ADDENDUM NO. 2

Bid #1449 Temporary Village Phase 5A Project
at
Santa Ana College

January 19, 2024

DSA ADDENDUM NO. 2

THRIVE CENTER VL-110 RCP PLAN 1/4" = 1'-0" 3

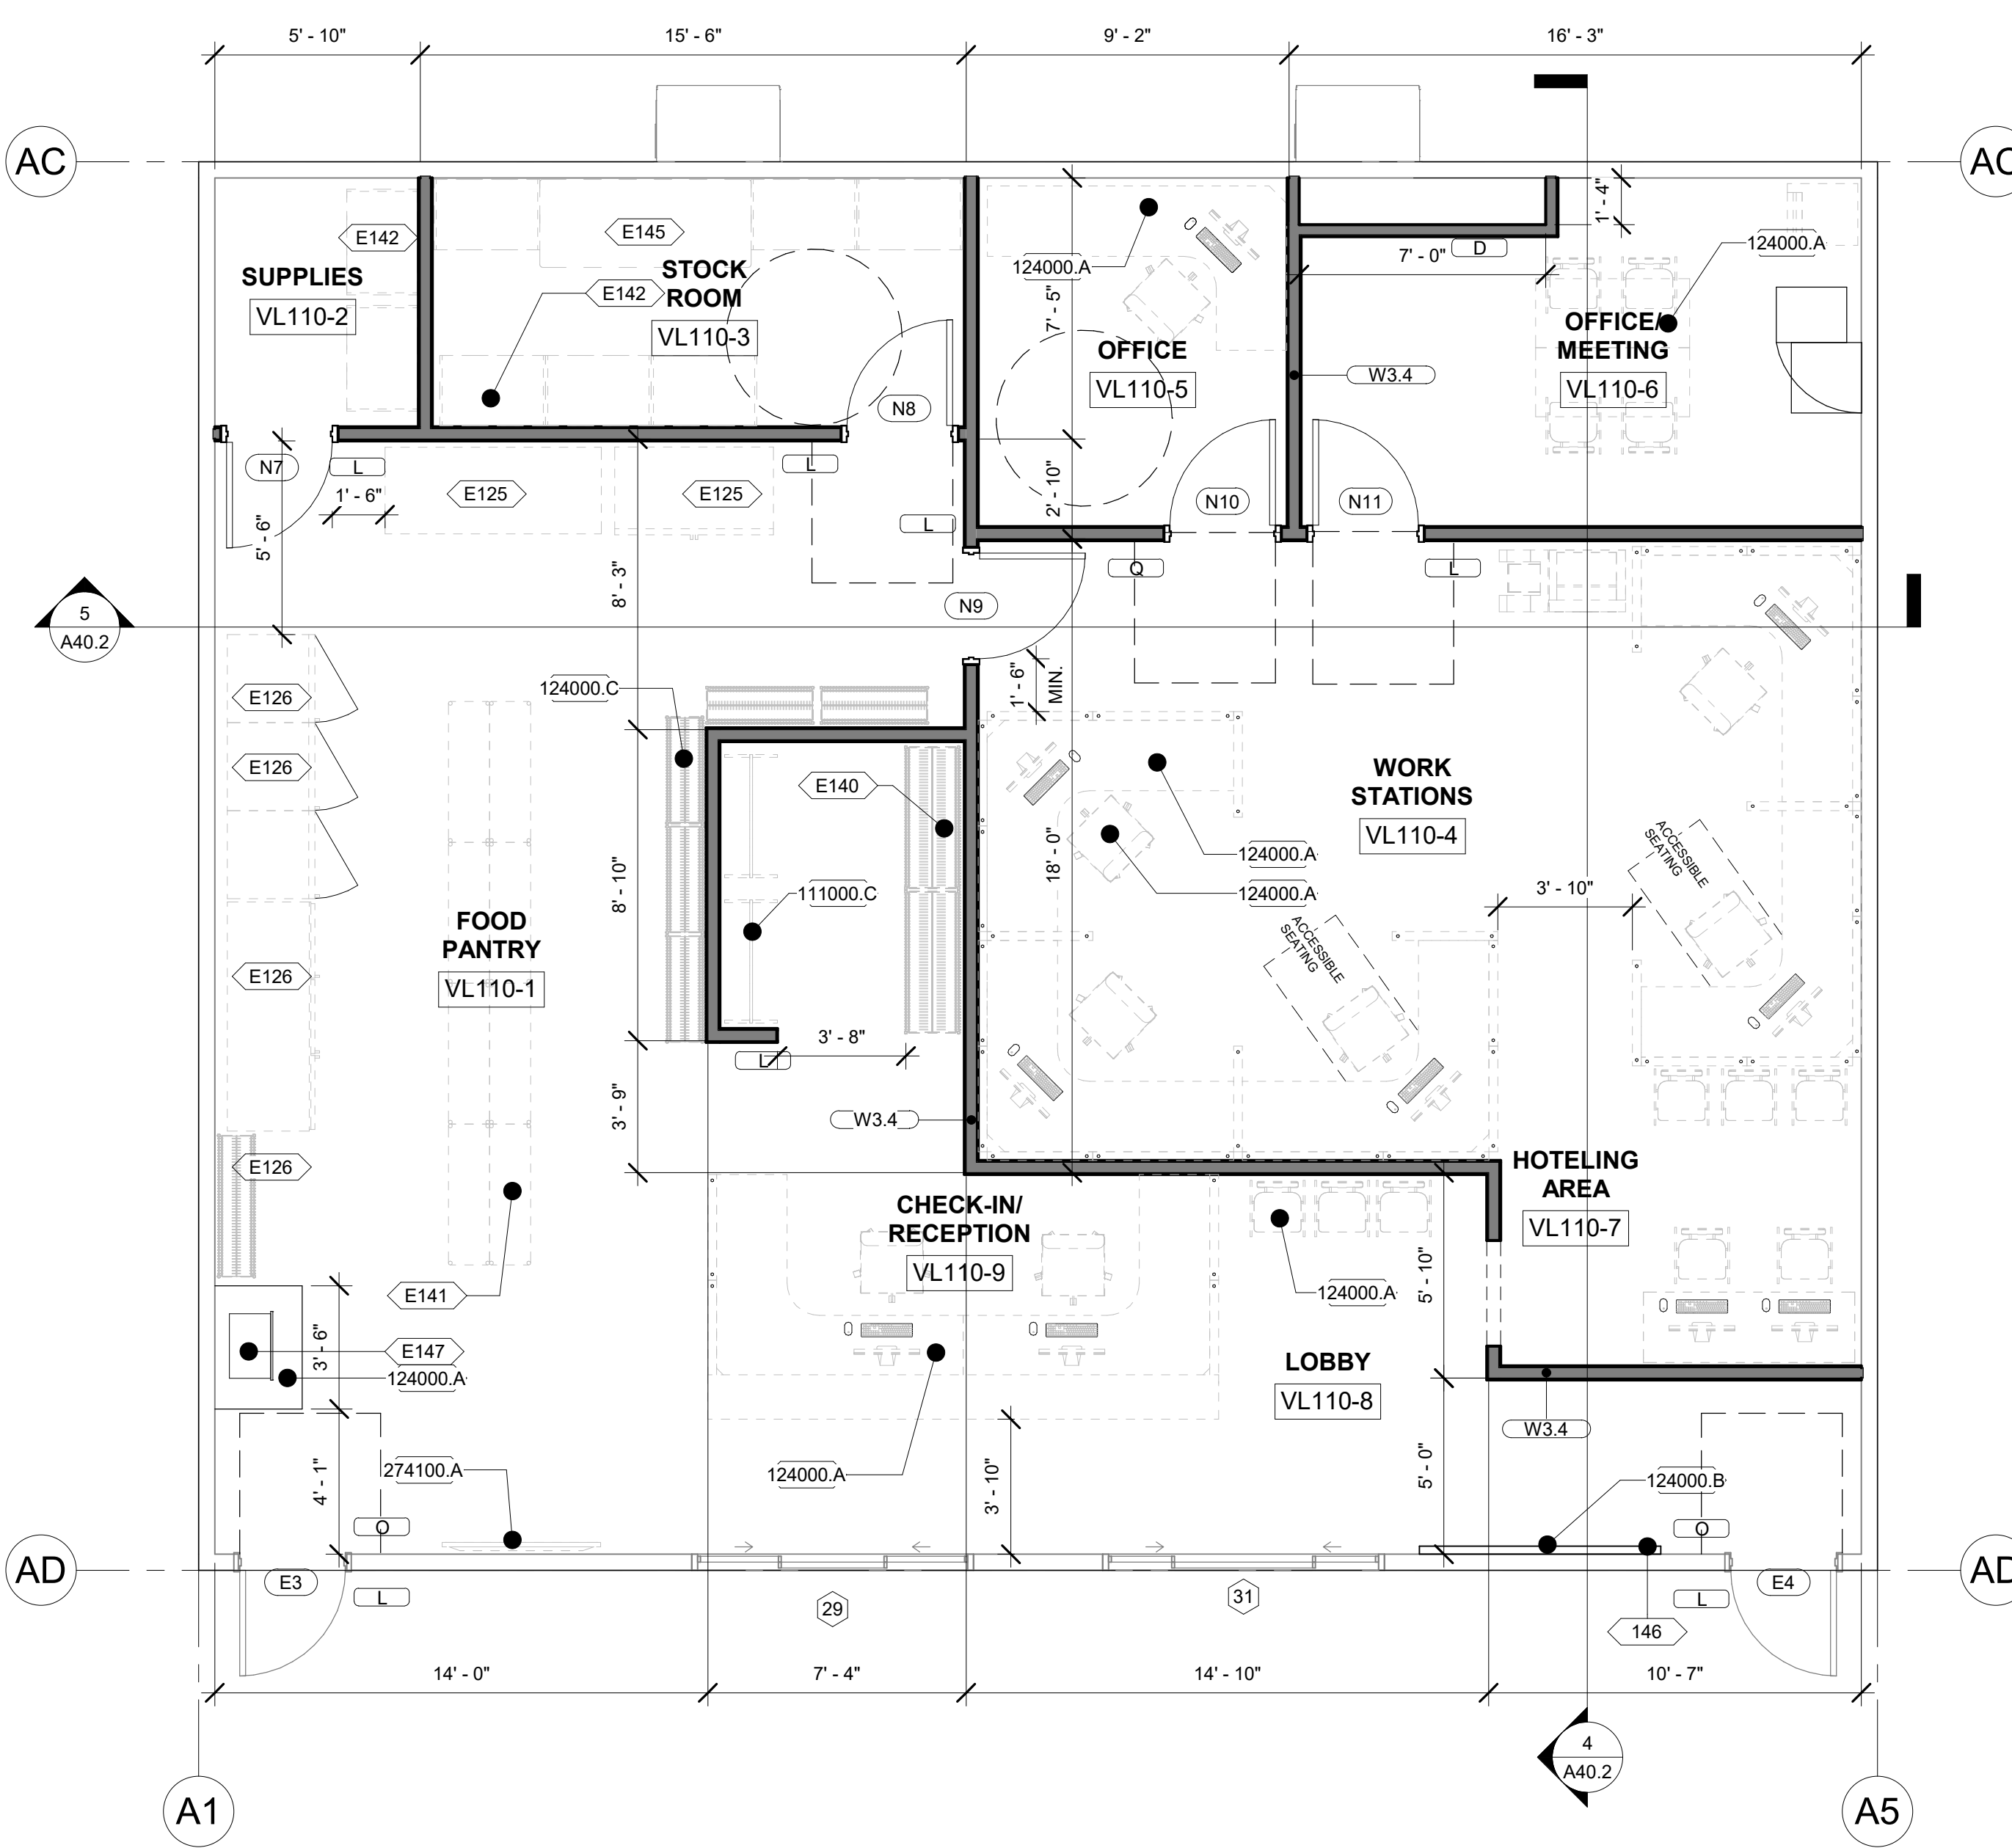
- b. Thrive Center VL-110 RCP Plan – Drawing updated to include new hatch to further clarify the conditions in the drawing.
10. Sheet A40.3 – Sewing Lab Enlarged Plans
